UNITED STATES PATENT AND TRADEMARK OFFICE

APPLICATION NO.	FILING DATE	FIRST NAMED INVENTOR	ATTORNEY DOCKET NO.	CONFIRMATION NO.
10/780,256	02/17/2004	Michael L. O'Banion	0275Y-625COC	3430

Office Action Summary	Application No. 10780,256	Applicant(s) O'BANION ET AL.	
	Examiner Katherine W. Mitchell	Art Unit 3677

DETAILED ACTION

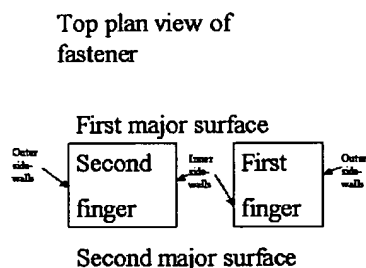
7. Examiner is assuming, based on an interview with attorney in related case 10/780072, that the major surfaces and sidewalls are arranged as below:

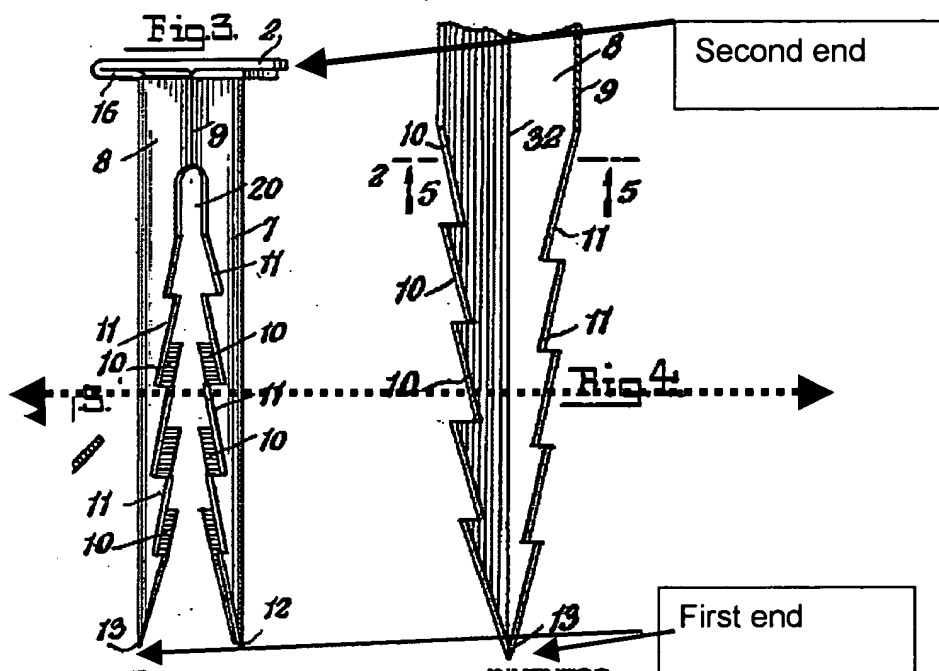
Re claim 85: Gisondi teaches in Figs 1-4 and col 2 lines 29-65 a nail capable of fastening framing members together comprising:

- a first end (13) configured to pierce framing members
- a second end (2) configured to receive a driving force
- a stem (8) extending between first and second ends, having an interior surface (concave interior –shown in Fig 4) and exterior surface (concave exterior shown on left in Fig 3) separated by 1st and 2nd edges (thickness of metal forming “11” and “10” respectively in Fig 4)
- a 1st set of teeth 11 extending axially along a portion of first edge
- a 2nd set of teeth 10 extending axially along a portion of second edge (see also col 2 lines 29-65)

Re claim 86: Fig 3 shows the lip (projecting past stem 8 at 16) which is capable of engaging a framing member

Re claim 87: Fig 3 shows each tooth having a radially extending surface

substantially parallel to said lip (flat upper edge of tooth) (all parallel to dotted line drawn in by examiner)

Re claim 88: Figs 3 and 4 show each tooth axially staggered relative to one another.

Re claim 89: Figs 3 and 4 show the lower portion of the stem reducing in cross section as the stem extends toward the first end. Note – examiner is defining cross section as viewed “cut” by examiner’s dotted line in Fig 3 and 4.

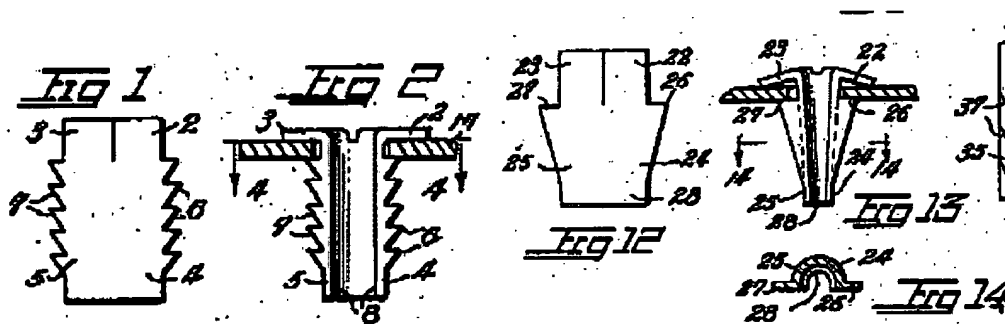
Re claims 97-98: Fig 4 shows 1st and 2nd edges at 9 (above cut line 5 in Fig 4)

as substantially parallel to each other. That same Figure 4 shows 1st and 2nd edges angled relative to one another (see for example, comparing both surfaces 10 to both surfaces 11 labeled in Fig 4.) {Applicant has not specified exactly how the edges must be parallel. For example, / and \ are parallel in that their "top face" lies in the same plane – i.e, they are on the plate of the paper. However, their orientation relative to the longitudinal axis of the paper is not parallel.}
